ACCESS AUDIT REPORT

KIRORI MAL COLLEGE

Sanjeevani Creations
A-130, Surajmal Vihar,
Delhi.

Pathways

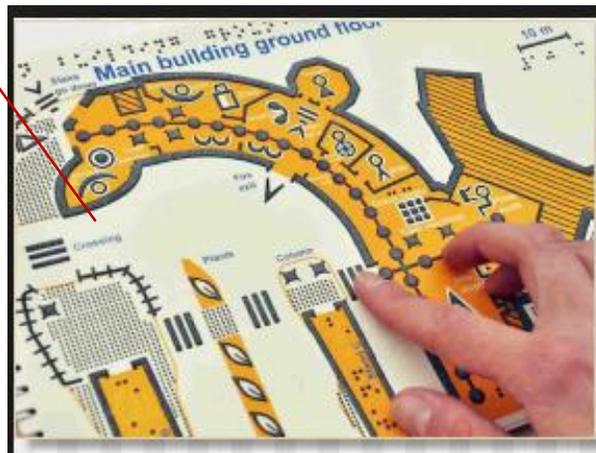
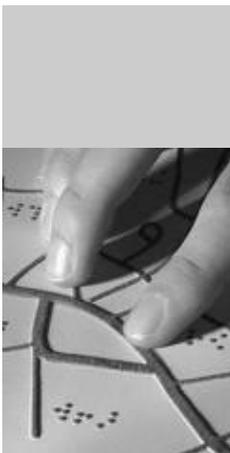
Loosely placed flower pots may hinder the movement persons with visual impairment

Broken Water Chambers may be dangerous for persons with partial or full visual impairment.

- ✓ Signboards to be provided at strategic location
- ✓ All signage to be mounted 2000mm from the footpath level
- ✓ The individual characters to be bold and the color should be in contrast to the background.
- ✓ For orientation and to avoid the above mentioned problem; it is suggested to provide Tactile preferably in colour contrast on the pathways, starting from entry to many different buildings.
- ✓ It is further proposed to provide dia. 50 mm & 0.3 m. high tap rail on either side of the pathways keeping flower pots behind.

Entry to Administrative building

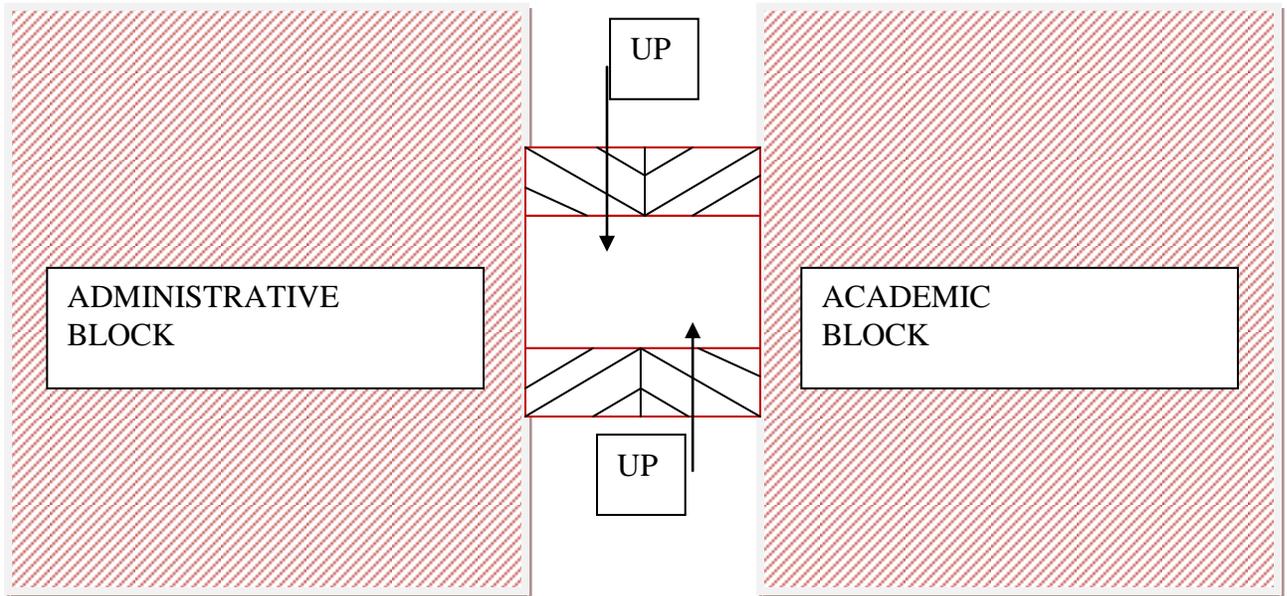
1. The ramps with good slopes were found at many entries i.e. Seminar room, library building, academic block. But at the entry of administrative building has a wooden ramp with inappropriate slope.

2. It is proposed to provide 3.0 m wide table top with 1:12 slopes on both the sides, as shown below.

No ramp for the accessibility to Prayas

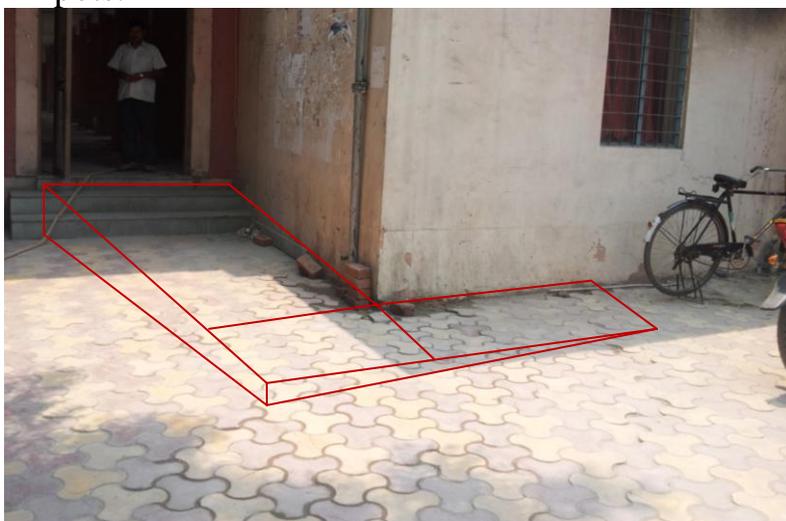
- No ramp has been observed at the entry to Prayas , Computer centre in the administrative block. It is thus proposed to provide 1.2 m. wide plinth at the existing level of corridor, connecting to the prayas and next room after removing the flower pots.

Proposed Ramp at the entry of Hostel Block.

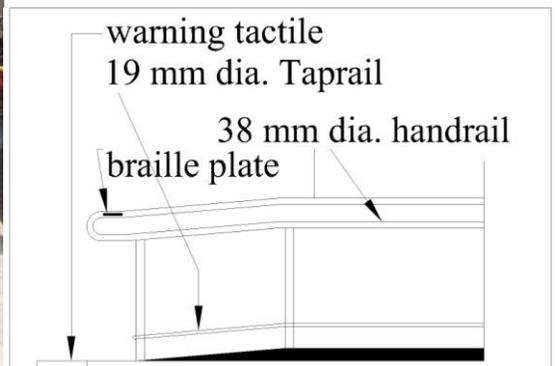
5. At the entry of the Hostel Block no ramp has been observed which may obstruct the entry of wheelchair to the hostel block. It is proposed to provide 1.2 m. wide Ramp of slope 1:12 with non slippery material along with the tactile arrangement at starting & ending of ramp. It is also proposed to provide 40 mm dia. handrail @ 0.9 m. along with Braille inscription on handrail at starting and end.

STAIRCASE

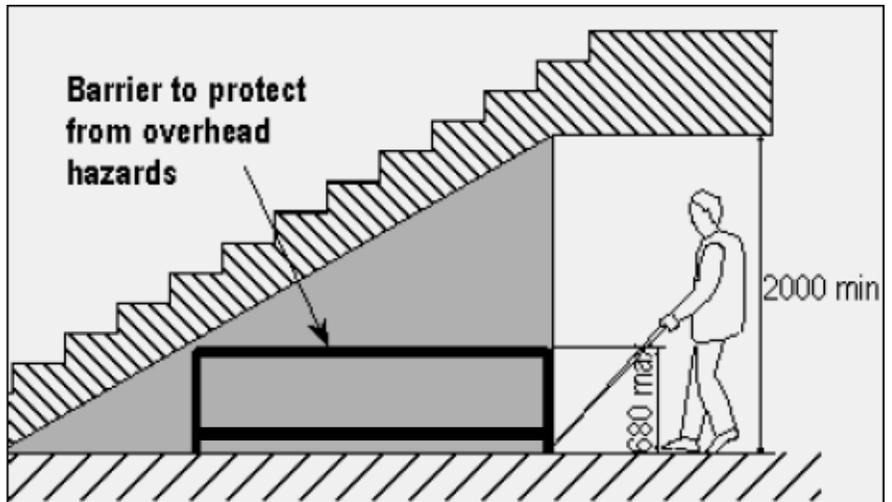
1. Straight flight staircase with landing in between has been provided for the vertical connection.
2. Handrail has been found at one side of the staircase.
3. The open soffit of the staircase could be dangerous for person with visual impairment as the white can only detect the obstruction up to 2'-0" height.

- ✓ Handrail should be provided at other side of the staircase on the wall.

- ✓ Warning strip and edges of the steps, to be as shown in the photograph.
- ✓ Color contrast in the steps and flooring can be provided for persons with low vision.
- ✓ Braille Plates should be fixed at starting & ending of handrails describing about the no. of steps, landings, destination i.e. going to first floor, etc.
- ✓ The refuge area below the staircase Should be closed upto 2.1 m by providing M.S. railing system to save from overhead injuries.

Narrow Aisle at stack room of library

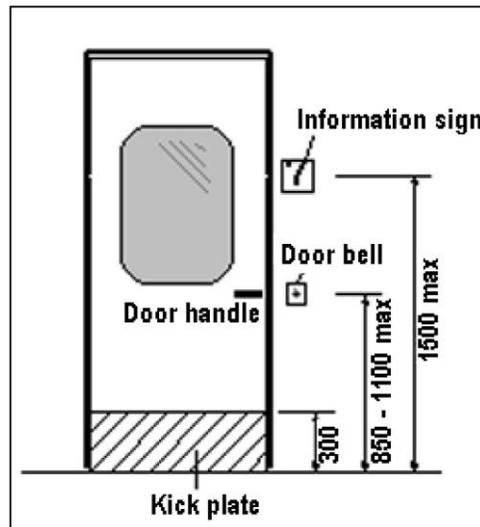
5. The narrow aisles have been observed inside the stack room of the library which could obstruct the movement of a student with a wheelchair, it is, therefore, proposed to keep the gap of 1.5 m. between the two racks of the books.
6. It is proposed to provide colour contrast between the floors & walls by putting the contrasting colour or band on the floor on both sides of the corridor.

Toilet for disabled

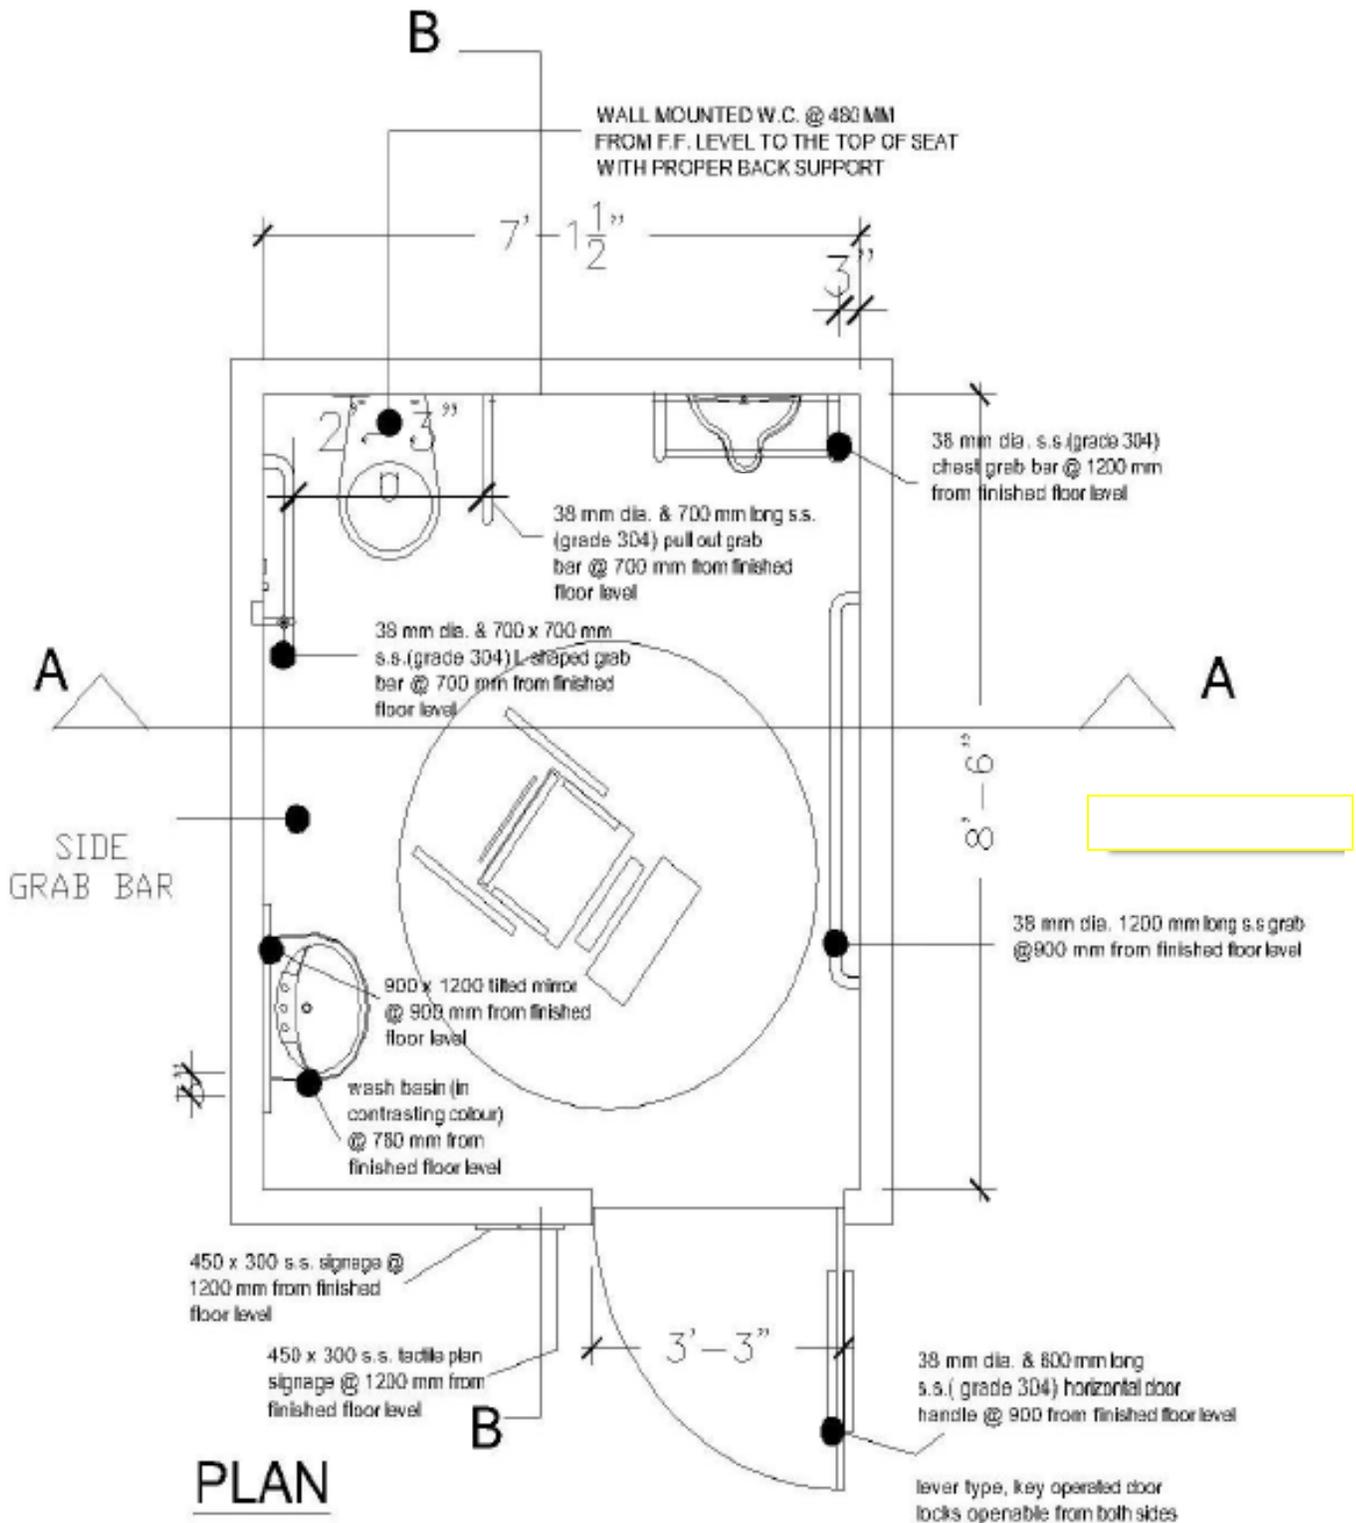
1. A disabled friendly toilet has been observed on ground floor at academic block.
2. Grabs bars at appropriate height on side wall has been observed.
3. Fixed Grab bar at other side of the WC has been observed, which is the hindrance for person with wheelchair to shift on the WC from the front side.
4. The signage provided outside the toilet is at very high location.
5. In all other toilets other than disabled friendly toilet few components are missed.

- ✓ Toilet should be provided with a door of clear opening of at least 900mm with the door swing outwards or be folding or sliding type
- ✓ Toilet should have slip resistant flooring

- ✓ Toilet should be provided with a horizontal pull bar at least 600mm long on the inside and 140mm long on the outside, at a height of 700mm
- ✓ There should have clear space of not less than 900mm wide next to the water closet

- ✓ The WC seat should be located between 460mm to 480mm from the centerline of the area to the adjacent wall and have a clear dimension of 800mm from the edge of the WC to the rear wall to facilitate side transfer.

- ✓ The top of the WC to be 475-490mm from the floor with a back support.
- ✓ 700 mm x 700 mm L-shaped S.S.Grab bars of 38 mm dia. should be provided at the rear and the adjacent wall. On the transfer side- swing away/up type and on the wall side L-shape grab bars should be provided.
